West Herr Lincoln
2601 Millersport Highway
Amherst, NY

Addendum 2
May 03, 2021
Page 1 of 8

A1 SITE PLAN
SCALE: 1" = 20'-0"

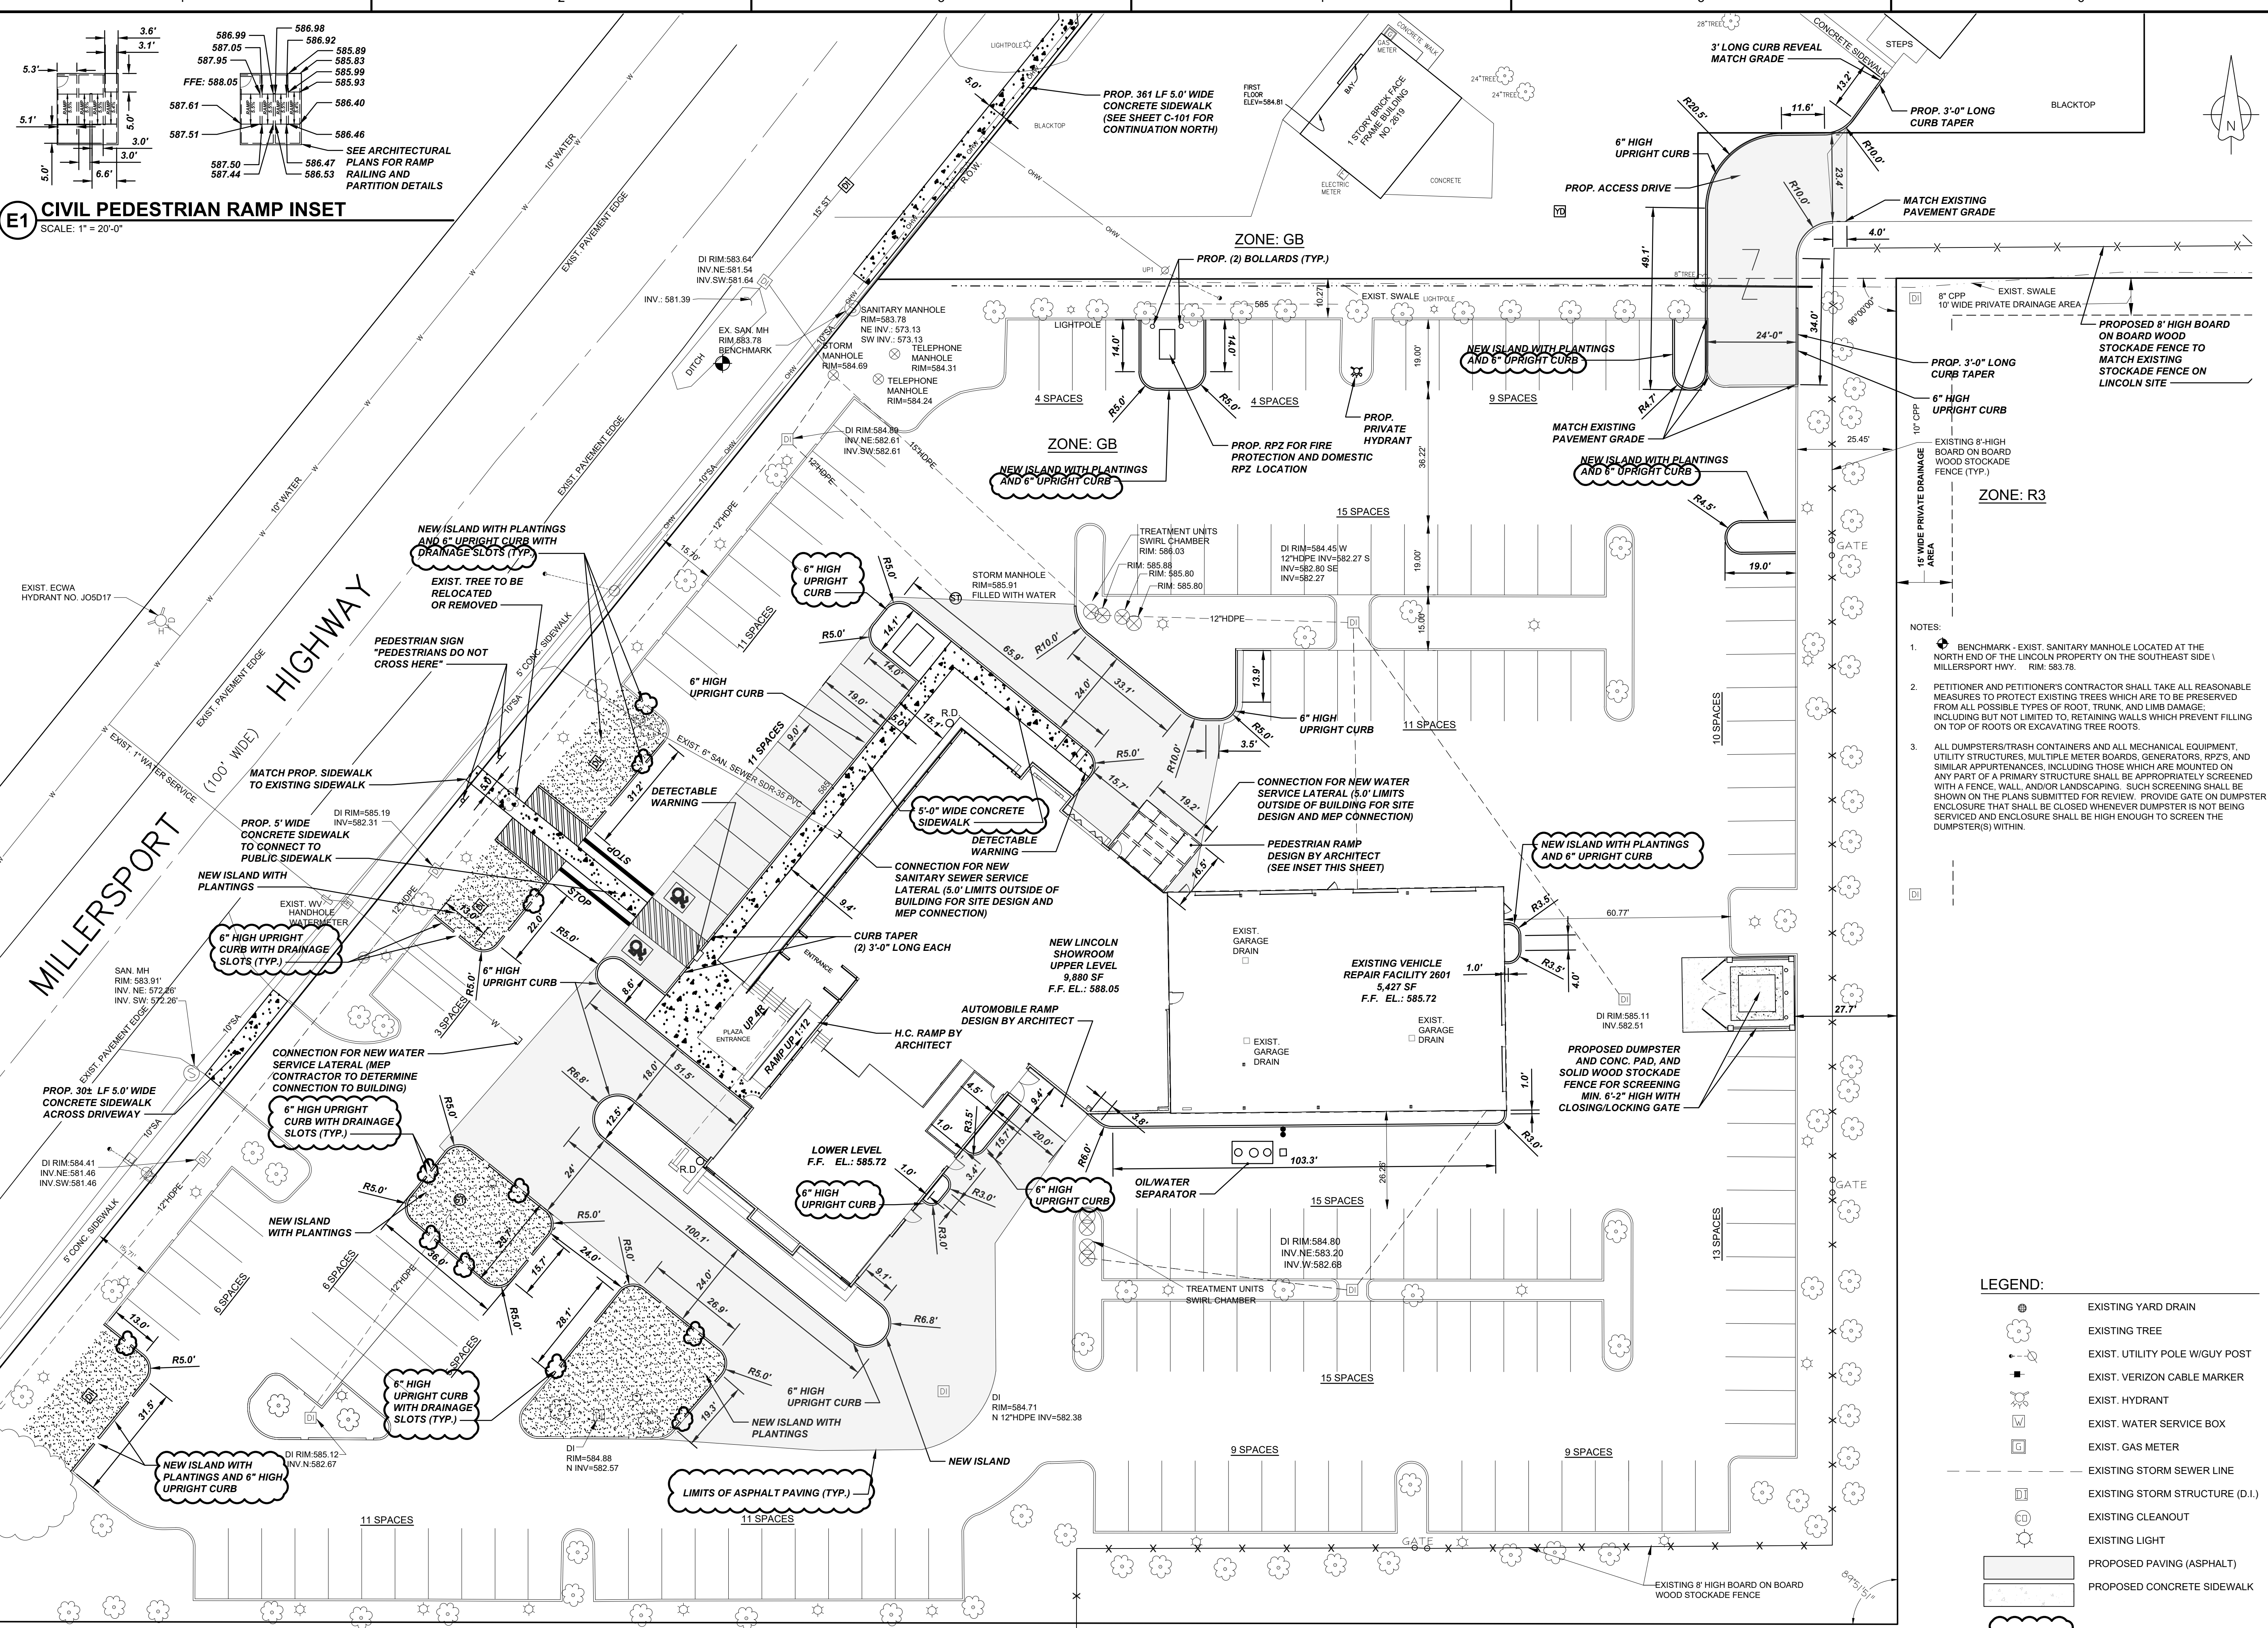
1. Plan appears to show curbing at a portions of North, East, South & West of the parking line as double lines. No call out provided to indicate that it is curbing. Please clarify.

5. Reference Site Plan C-104: It is assumed that concrete paving is required at the new building, but it is not clearly called out. There is also no detail to reference. Please provide a revised drawing showing the limits of the concrete paving required at the new building and provide a detail.
The drawing does not all out concrete paving. The limit of paving replacement indicates asphalt paving. Only the new sidewalks are to be concrete.

9. Fence:
 - a. C-104 calls out new board on board fence but detail on C-113 seems to show a full two-sided fence. However, I think the existing fence is a standard solid board fence with 3 rails. What should we include? **Match existing.**
 - b. What type of wood? We assume pressure treated. **Match existing.**

Answer: I have put callouts for the 6" upright curbs and have added a few more drainage slots. All revisions are clouded so you can see where they are. I have attached PDF's of sheets C-104 and C-105 with the revisions clouded.

A1 WALL SECTION @ RUNWAY (THROUGH HIGH LIGHT-WELL CEILING)
 SCALE: 3/4" = 1'-0"

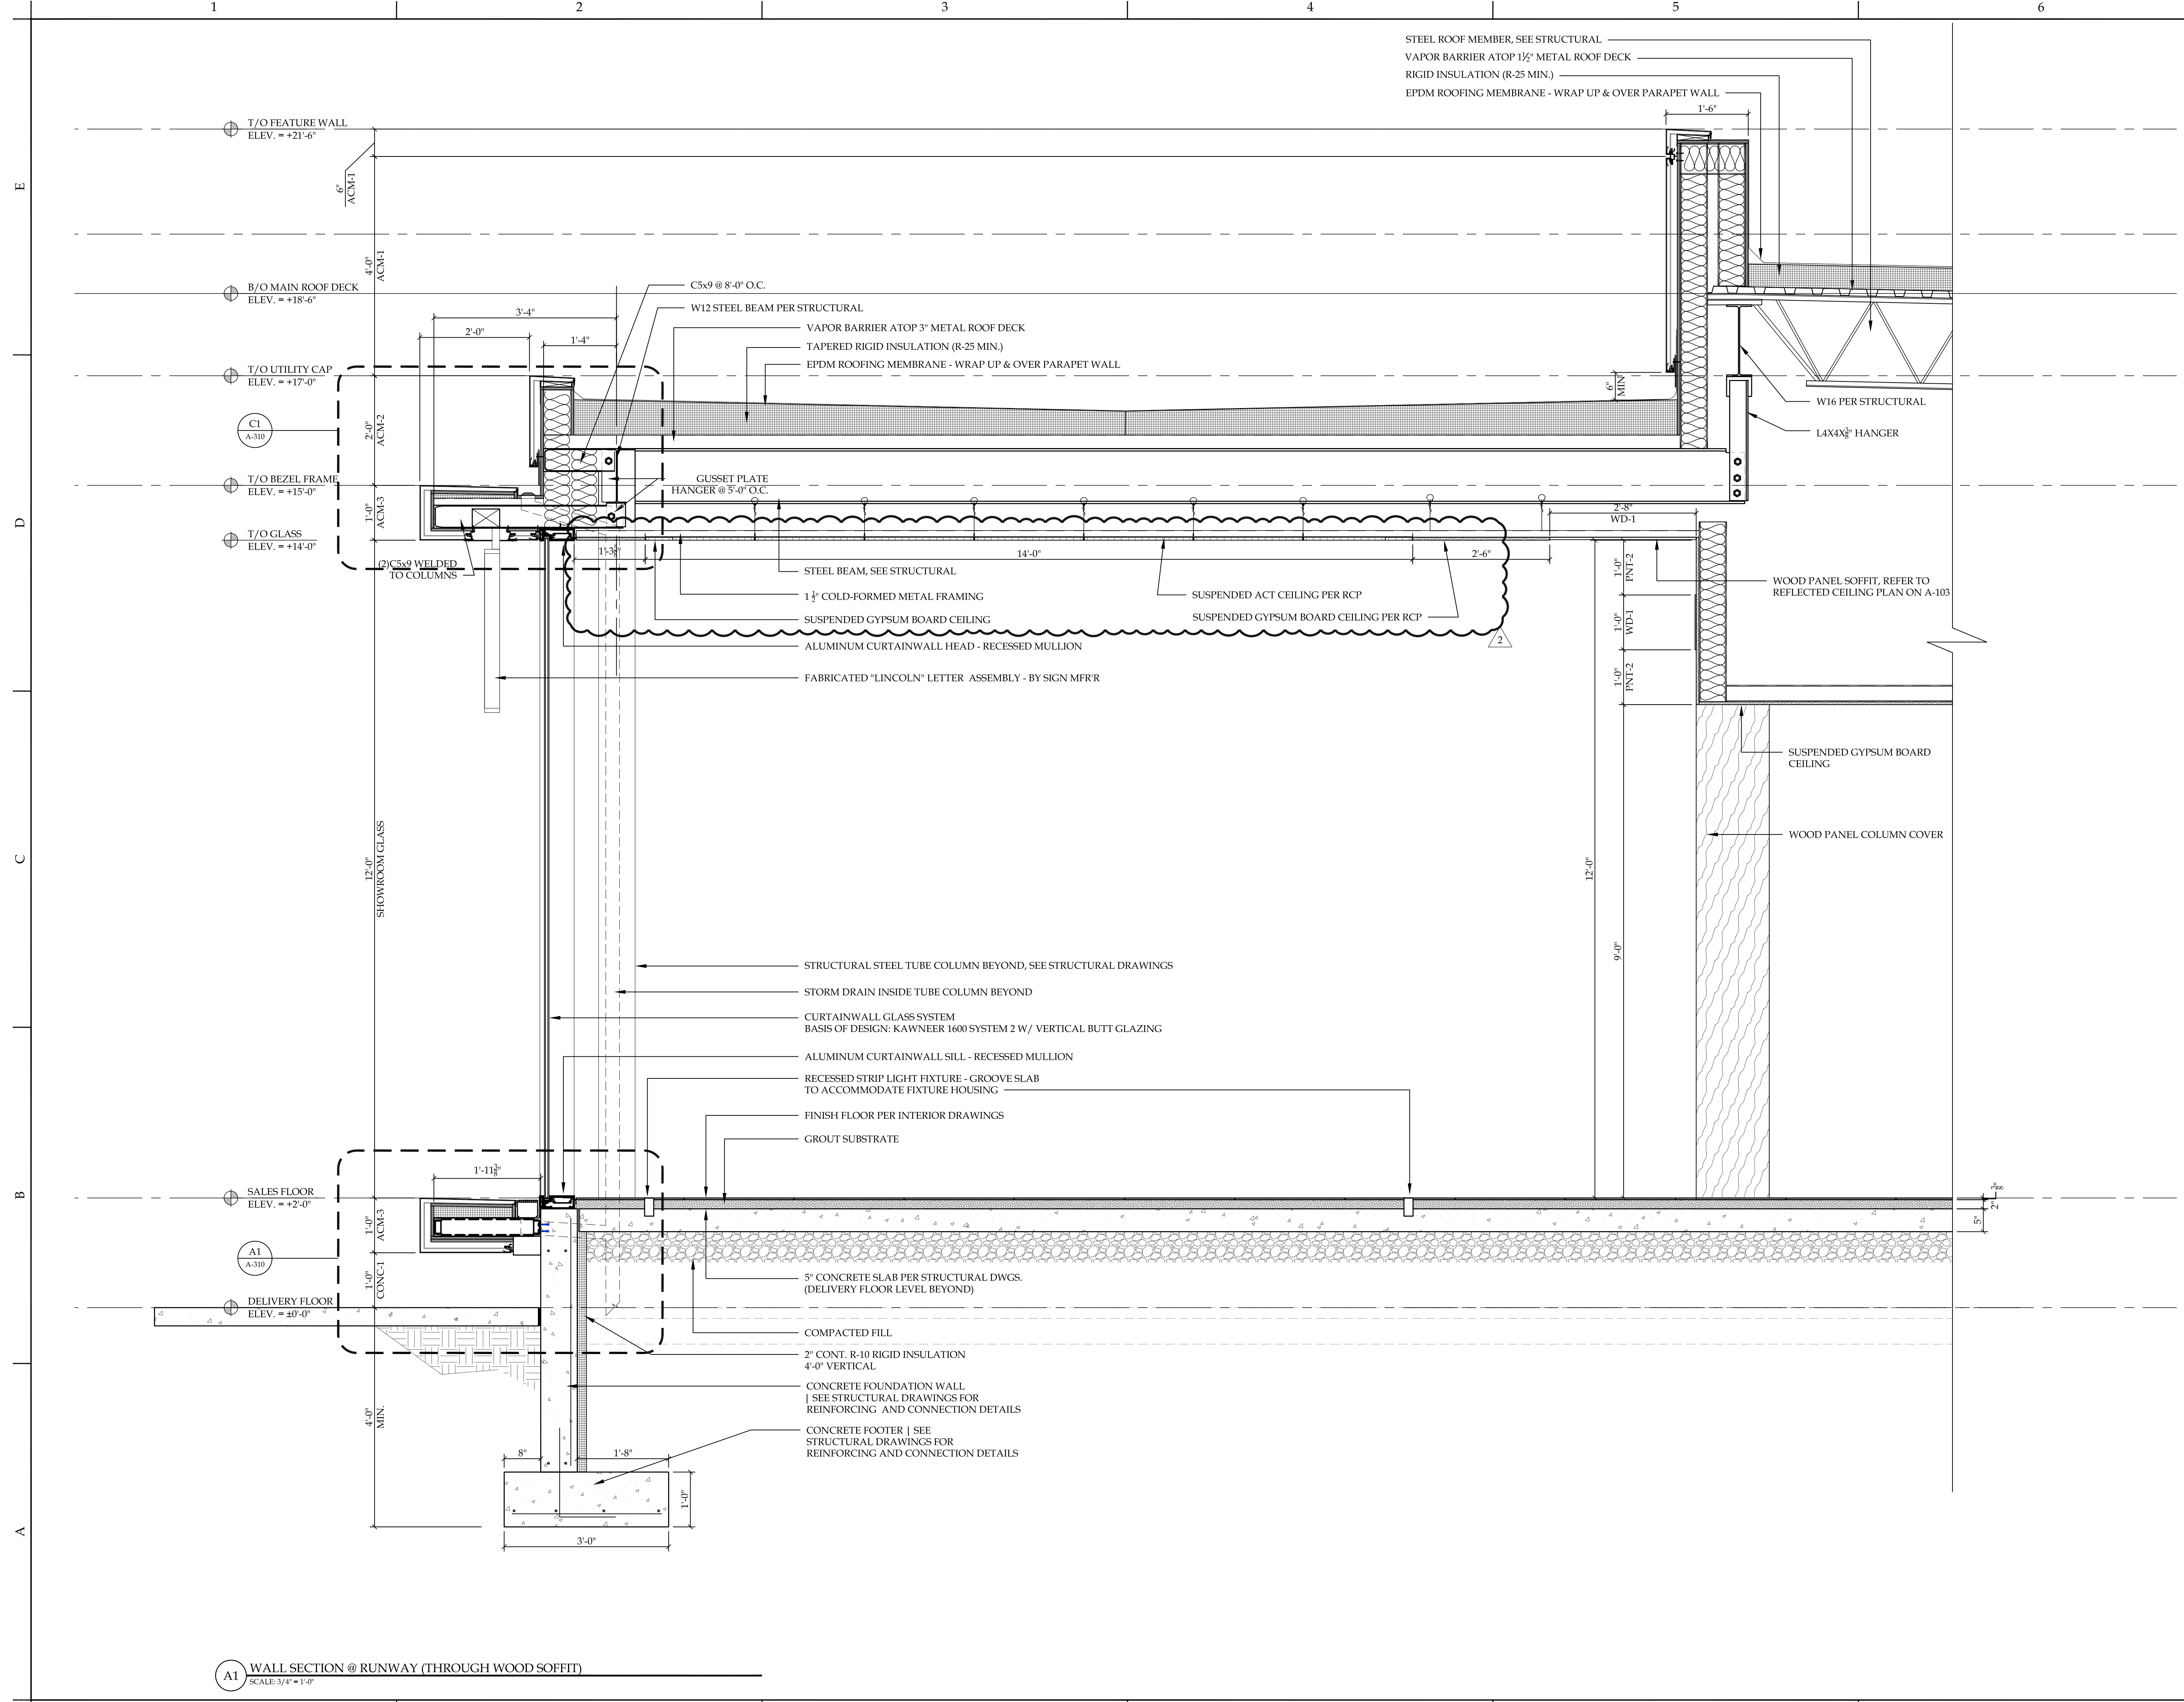
5. Reference RCP on drawing A-103 - Acoustical ceiling and a suspended gyp. ceiling is shown in the vehicle display area. Sections A1/A301 and A1/A302 show a drywall ceiling in these areas only, and does not detail soffits otherwise. Please clarify.

7. Reference Wall Section drawings A301 & A302 – Please confirm that the 2” grout substrate shown is required. Can flooring be installed directly to concrete floor?

Answer: Ceilings should be as shown on the RCP A-103. See revised details A1/A301 and A1/A302 updated to correspond.

Answer: 2” grout substrate is required to accommodate the curtain wall recessed mullion.
